**Response of CEB to the Final Report of the
committee appointed by the Ministry of
Power to investigate power system failures
on November 29, 2021 and December 03,
2021**

25 March 2022

Figure 4.2-1 CFC logic diagram of End-Fault Function Implementation in the SIEMENS 7SS522 Relay

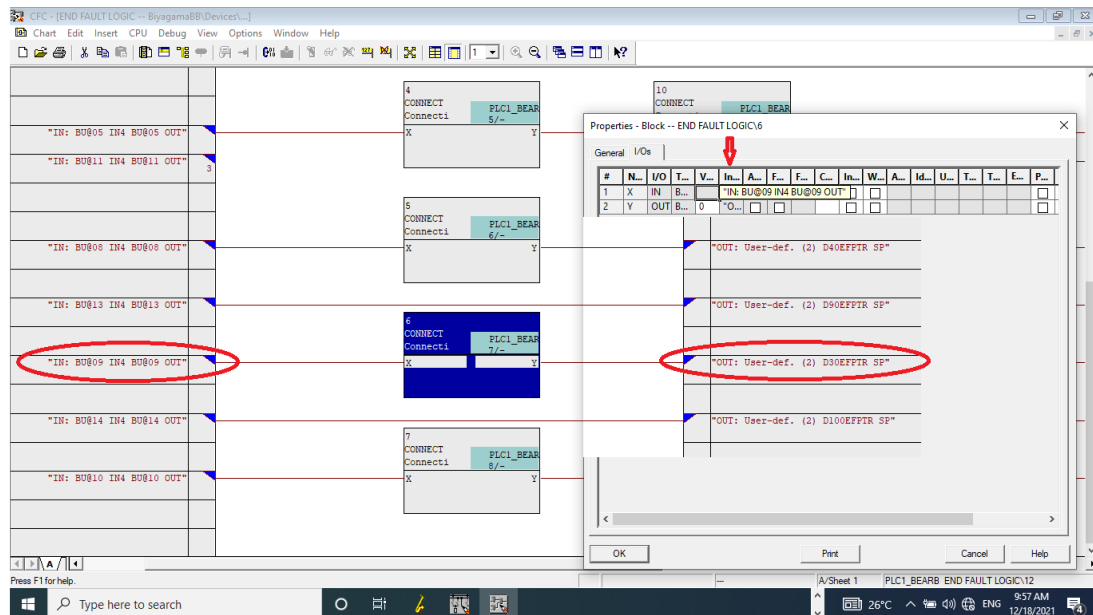
The Committee studied the end-fault logic implemented in SIEMENS 7SS522 relay from the records in the relay accessed using DIGSI V4.93 software. Figure shows the screenshot highlighting the output generated by the D30EFPTR using the relay function block. The properties of the function block reveal that only the neutral current (IN) is taken as the input. Accordingly, when IN exceeds a certain threshold, the end-fault tripping is activated.

In Siemens 7SS52 BusBar Protection Scheme, the trip decision of End Fault Protection (EFP) is carried out by the Bus Bar Protection Bay Unit of each 220 kV bay. Anyhow, these bay units are not compatible with the IEC61850 protocol which has been the one used in Biyagama to provide information of the relays to the Substation Automation System (SAS). So, the busbar central unit which is compatible with IEC61850 protocol has been used to provide the operation of end fault protection indication of each bay to the existing SAS by taking the same information of the bay unit to the central unit through a proprietary protocol existing between the two relays. So, the CFC logic diagram depicted in the committee report is only used to send the indication of end fault operation of each bay unit to BB central unit and thereby to the SAS. The input "IN: BU@09 IN4 BU@09 OUT" in the left side of the Figure is used as the 4th digital signal of bay unit 09 (Kothmale 02) shared with the central unit. The text "IN: " has been used to represent an input in the CFC logic diagrams & the same "IN: " can be clearly seen in front of all the inputs in CFC logic sheets as well.

Figure 4.3-1 End Fault Protection Scheme Block Diagram

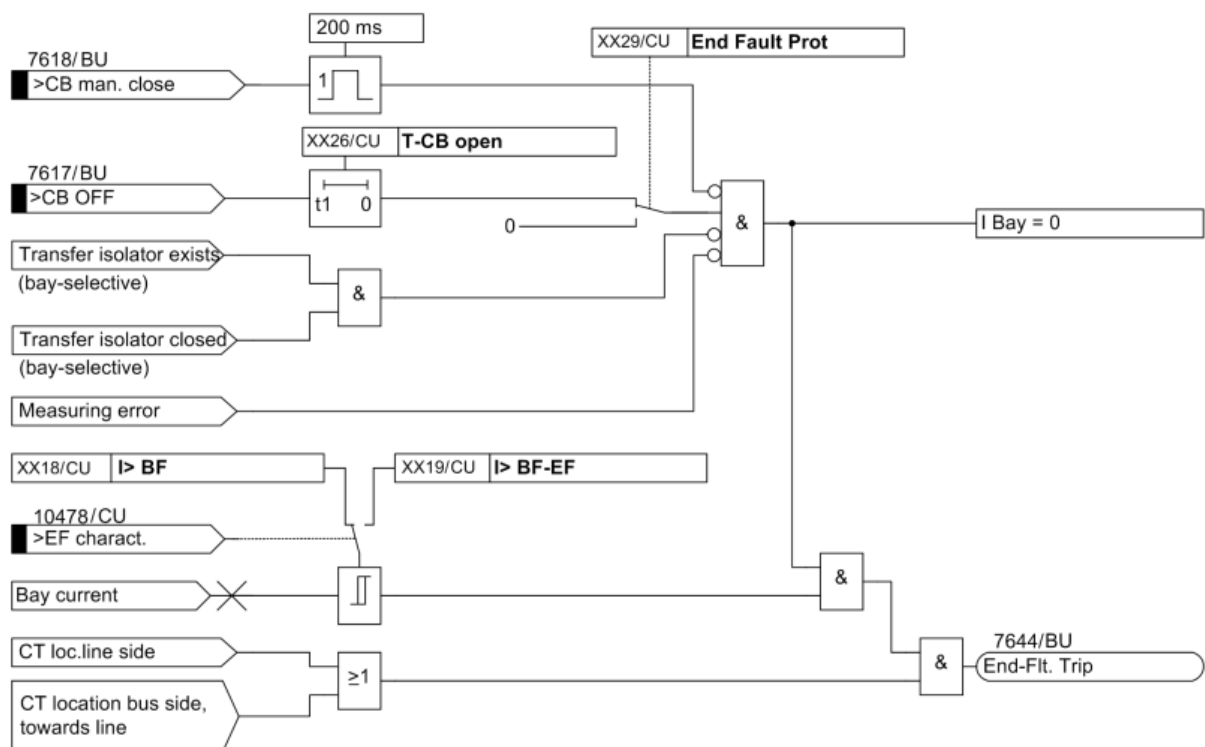
As per the below logic diagram, the end fault protection of the SIEMENS 7SS52 relay uses “Bay Current” value for the operation of the end fault protection. It uses the current value of “I>BF” setting as the threshold value for the end fault protection, which is 500 A in this case. Further, under the section “5.3.2 Setting Notes” related to the “Circuit Breaker Failure Protection” in the same manual, it is clearly mentioned that the parameter “I>BF” is also used for the function “End Fault Protection”.

While CEB agree with the Committee that End Fault Protection should have received serious consideration of protection staff but as per CEB explanation submitted above the following statements made by the Committee with regard to End Fault Protection Scheme are not correct.

Hence, in this particular case, it is not the 80 A threshold setting that had caused circuit 1 to trip. It was the “Reset” configuration setting of “Disk Emulation” instead of “Instantaneous”, which has caused the tripping after 22.33 s. The CEB has failed to provide an explanation for choosing this setting only in the Kothmale end whereas the corresponding setting on the Biyagama end of the same circuit was set to “Instantaneous” (in the signed report “Disk Emulation”).

Figure 4.5-1 Relay bias characteristic

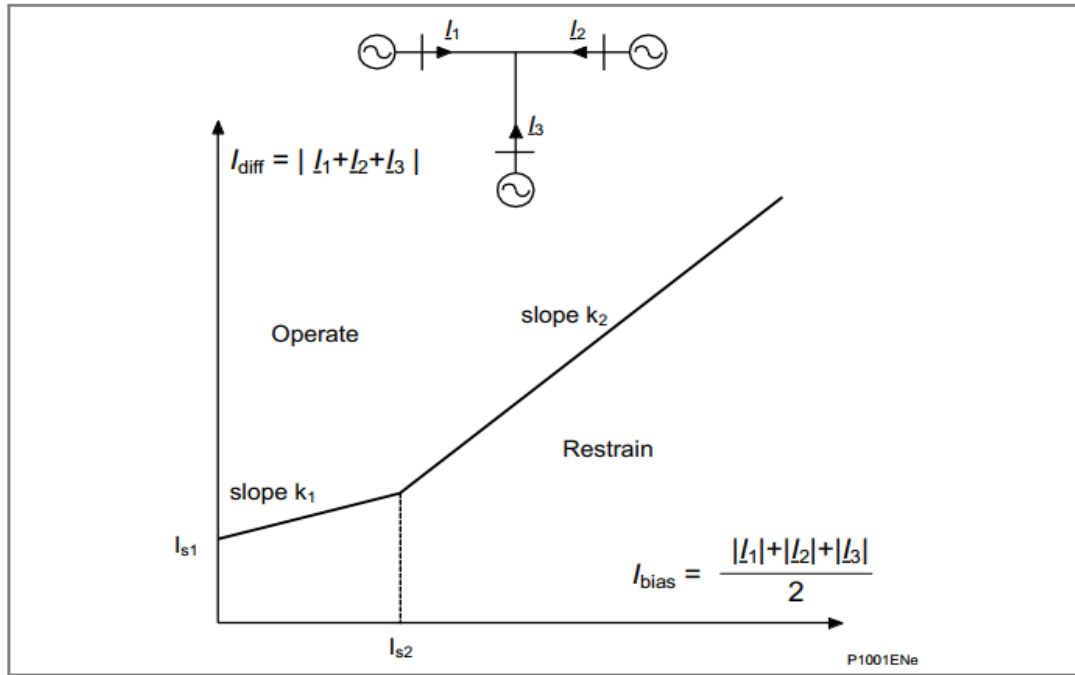
CEB has noted that the Committee has made an incorrect determination that Main 2 Differential Protection Relay has operated on 2021-12-03.

None of the Main 2 (MiCOM) relays have operated during the incident on 2021-12-03. In line 2, the differential current is around 520A. As per the algorithm of differential function of Main 2 relay, fault has not entered the tripping region.
